Our Case Number: ABP-317660-23

**Re:** Busconnects Kimmage to city centre core bus corridor scheme  
Kimmage, Dublin

## KIMMAGE TO CITY CENTRE CORE BUS CORRIDOR SCHEMELANDSCAPING AND URBAN REALM

**BCIDD-ROT-ENV\_LA-0011\_ML\_00-DR-LL-0005 Sheet 4 of 14 (general note to entire route)**

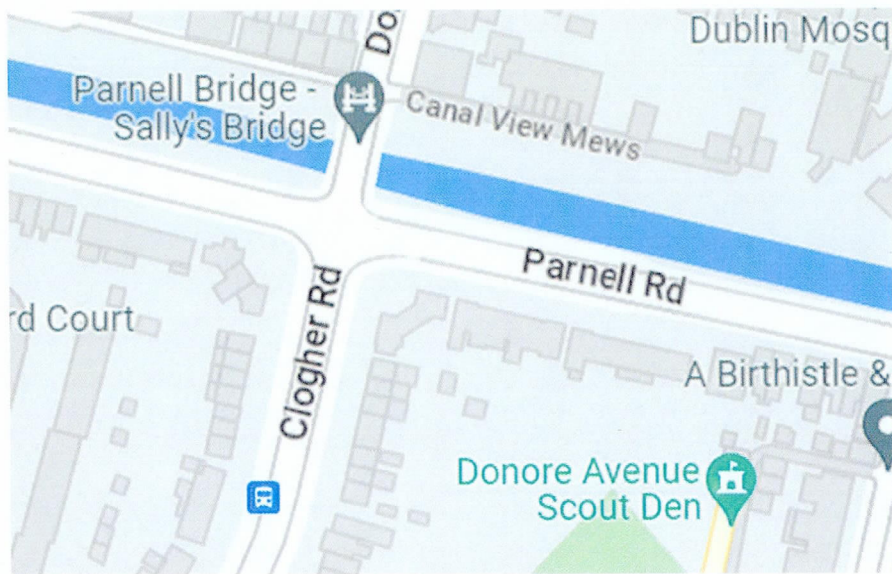
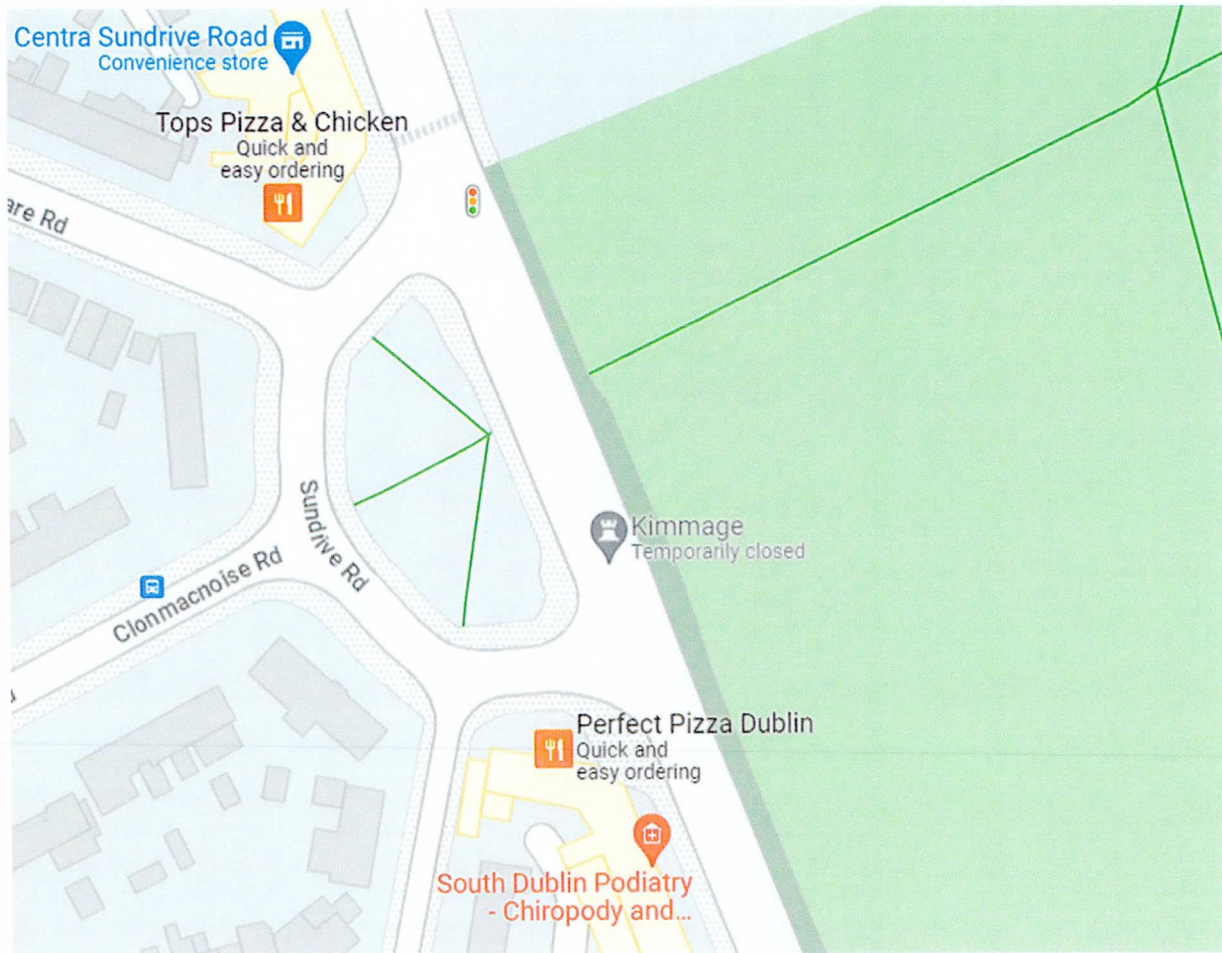
There are existing telephone / light / sign poles which are poorly located which prevent two way traffic due to minimum distance between poles & boundary wall to footpath. It is an particularly an issue when meeting with prams or wheelchairs The concrete foot paths have been shown as yellow indicating no amendment to locations. These poles should be repositioned while the improvement works are underway. Suggest survey carried out to determine locations to full layout (sheet 1 – 14) and correct amend within layouts. See below photo for example

There are existing telephone / light / sign poles which are poorly located which prevent two way walking traffic due to minimum distance between poles & boundary wall to the footpath. The concrete foot paths have been shown as yellow indicating no amendment to locations. This poles should be repositioned while the works are underway. These poles should be repositioned while the

improvement works are underway. Suggest survey carried out to determine locations to full layout (sheet 1 – 14) and correct amend within layouts. See below photo for example.

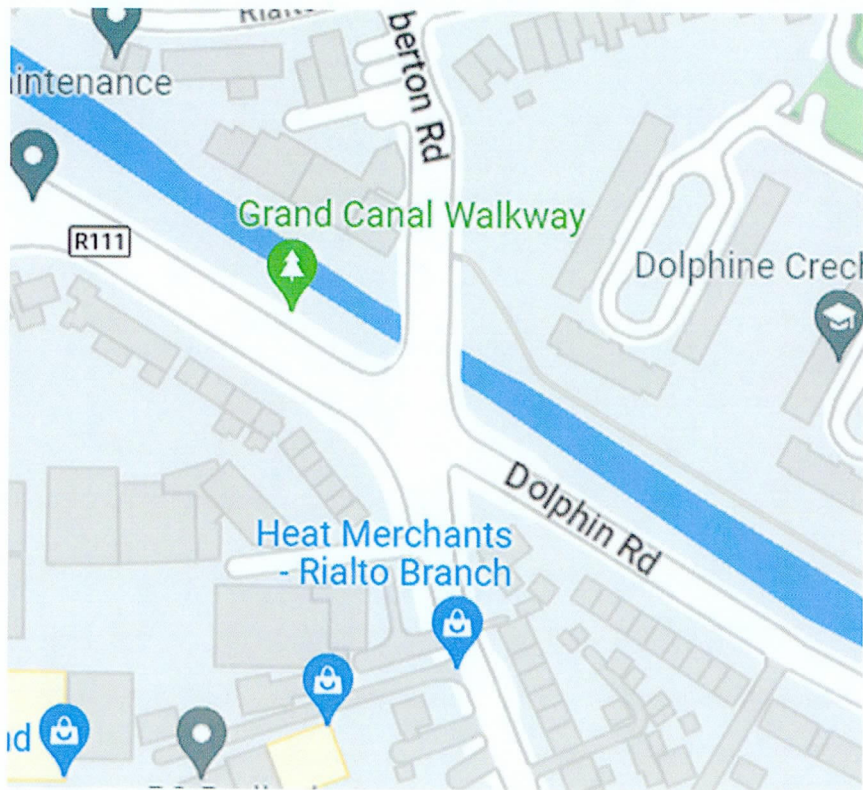
There are existing telephone / light / sign poles which are poorly located which prevent two way walking traffic due to minimum distance between poles & boundary wall to the footpath. Suggest survey carried out to determine locations to full layout (sheet 1 – 14) and correct amend within layouts.

BCIDD-ROT-ENV\_LA-0011\_ML\_00-DR-LL-0003 Sheet 3 of 4

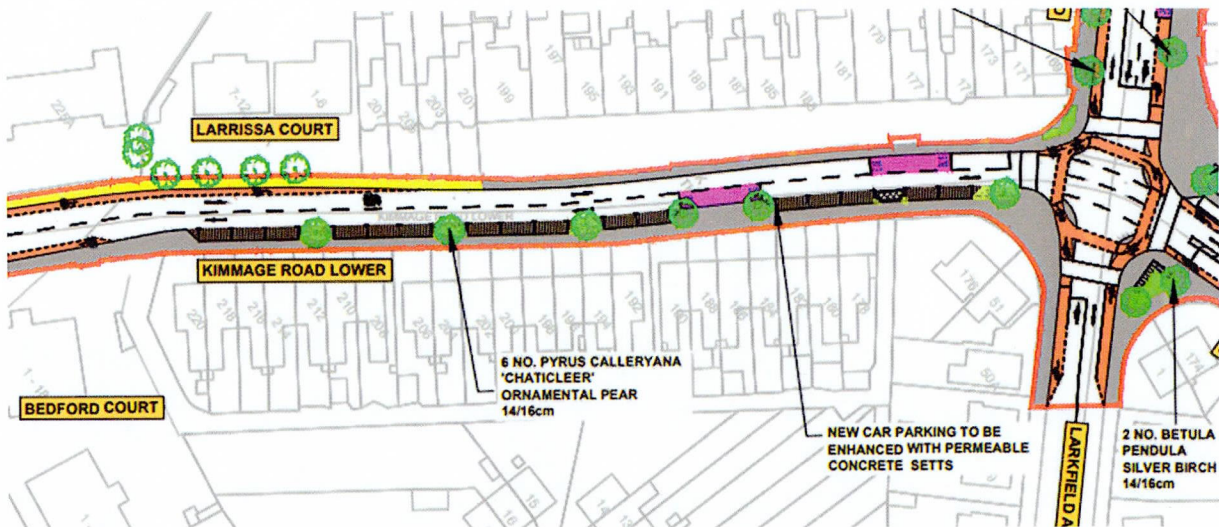
There are less tree provisions being provided to Lower Kimmage Road / Sundrive Rd road junction than was shown in the preferred route PDF issued previously. Suggest increasing.
